AGENDA
CITY OF TAYLOR, TEXAS
PLANNING & ZONING COMMISSION MEETING
TAYLOR CITY HALL COUNCIL CHAMBERS
MAY 14, 2024, 6:00 PM

Staff has completed its review of plans for the Castlewood South Subdivision phase 2 Final Plat that is to be located at FM 973, Taylor 76574. There are some corrections that need to be made prior to acceptance of the plat. Comments from this review follow.

Staff has completed its review of plans for the Park 79 Commerce Center Taylor Tract - Public Improvements that is to be located at 14501 Highway 79, Taylor 76574. There are some corrections that need to be made prior to approval of these plans. Comments from this review follow.

Urban Design Comments

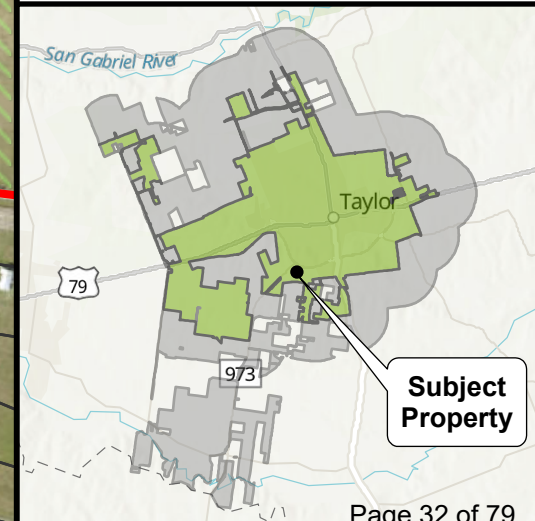
- ① The dimensions of all lots should be consistent with those specified for each Transect Zone in the PD Standards (see the Lot Standards and Urban Standards).

- ② In the PD Standards, these lots are shown as private lots with commercial and residential buildings, not open space or drainage. The adjustment shown is not consistent with the PD Standards (see the Regulating Plan and Civic Space Plan).

- ⑦ In the PD Standards, a Civic Space is shown here to create a break in Block F (see the Civic Space Plan).
- ⑧ Corners of RsOW should not be radiused. Wherever possible, radii for turning movements should be accommodated through the shape of the curb, not the ROW or alley.

- ⑨ Bulbouts should be avoided with the exception of specific locations shown on the Master Plan in the PD Standards.
